**Project:** 561 - Dacula City Core  
2506 Sanjo Street  
Dacula, Georgia 30019

**Prime Contract Potential Change Order #021: CE #021 - Maple Creek Park Entrance (RFP #8)**

**REQUEST FOR PROPOSAL NO.:** 08

**PROJECT:** Maple Creek Park:  
Entrance Improvements

**1 SLEEVING PLAN**  
SCALE: 1" = 10'-0"

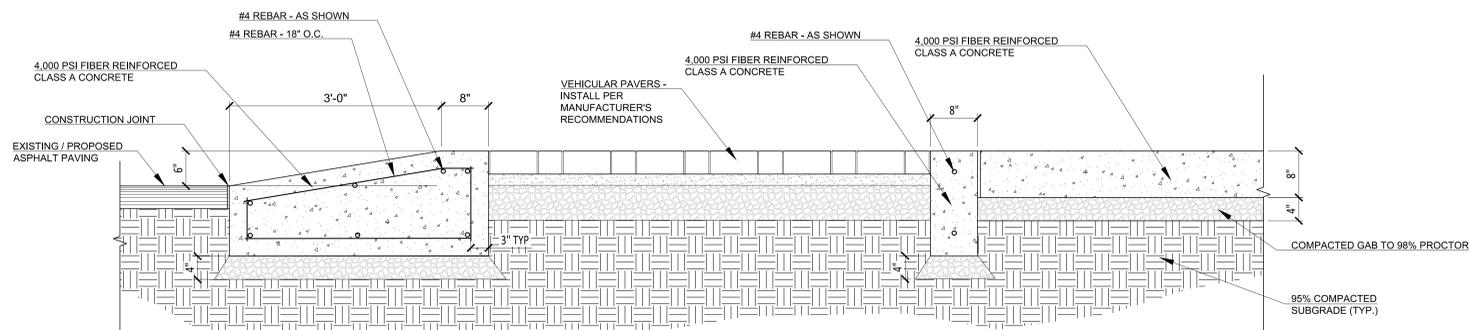
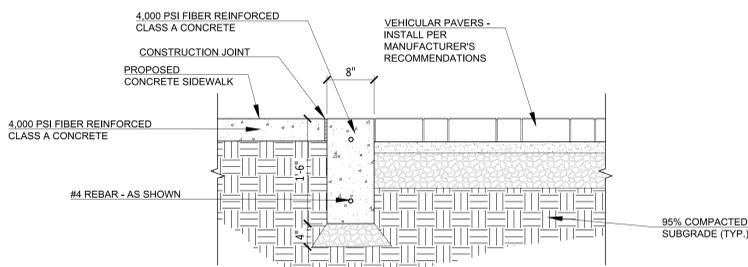
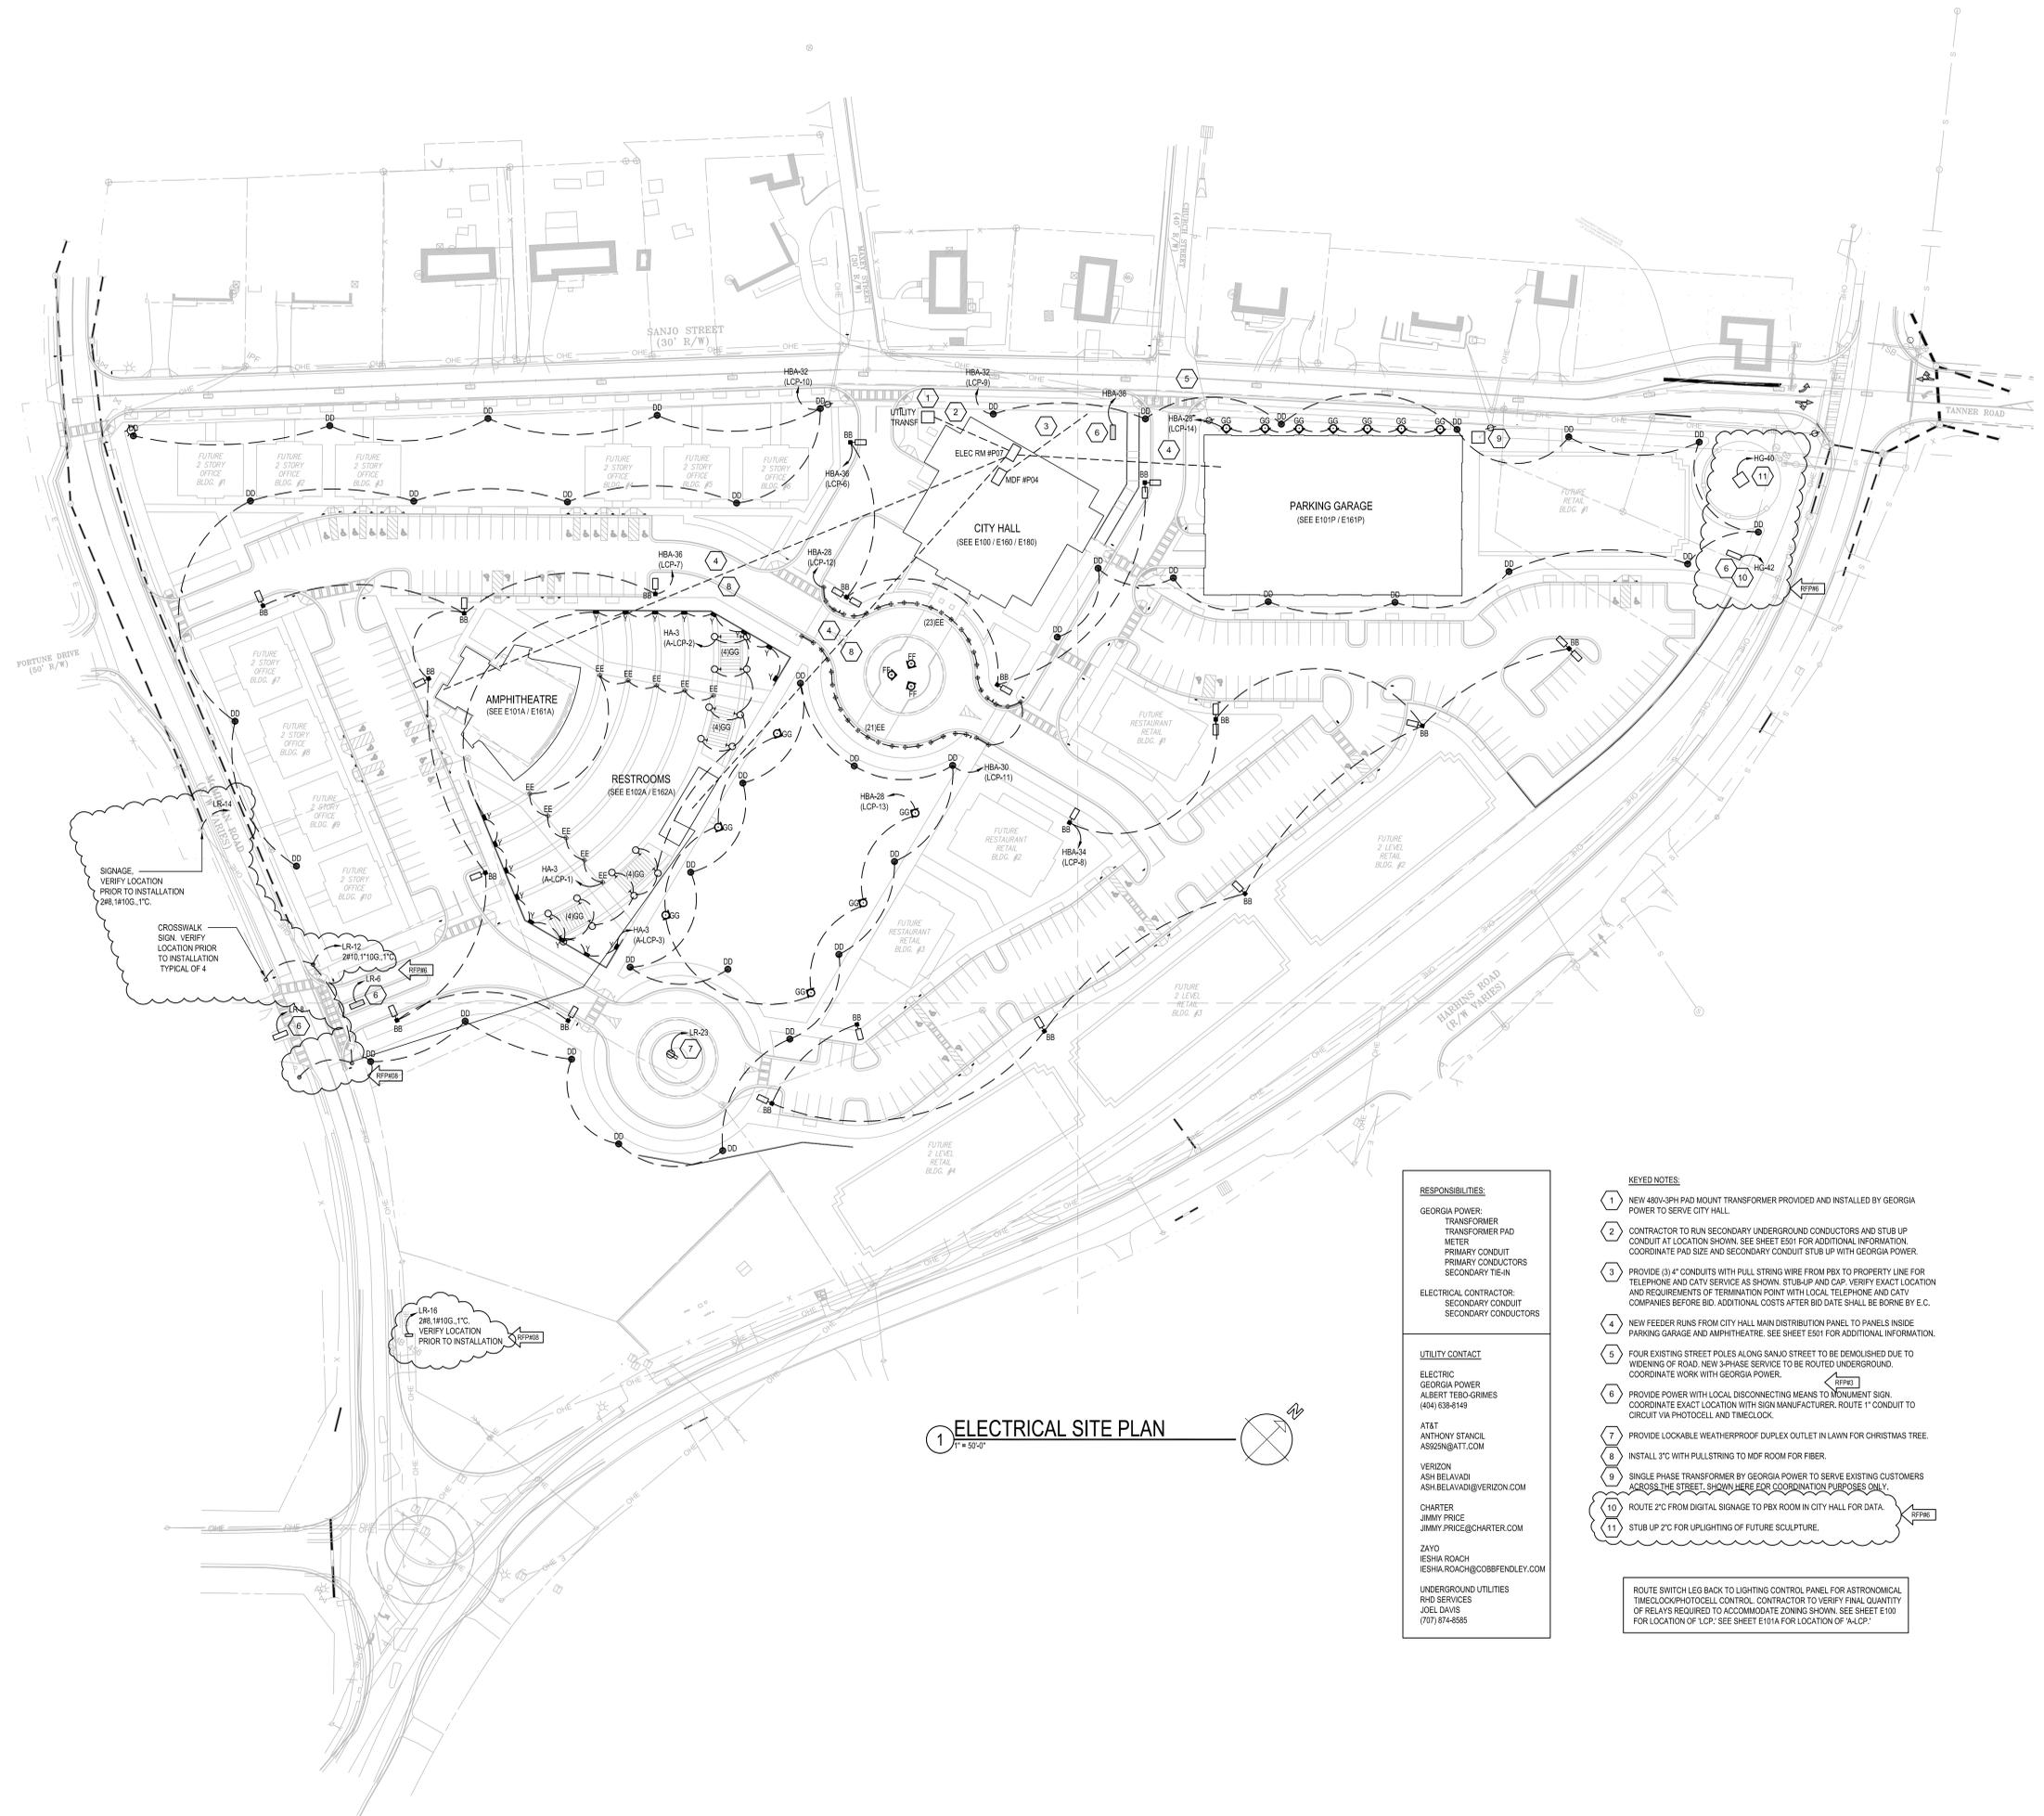
Provide a price to the Owner for revision to the following item as shown on the attached revised drawings: G000, G001, C1.0, C2.0, C3.0, C4.0, AS100, AS101, and AS102

- 1. Maple Creek Entrance: Monument sign, Demolition, Landscaping, Brick pilaster/alum fence along McMillan and various improvements
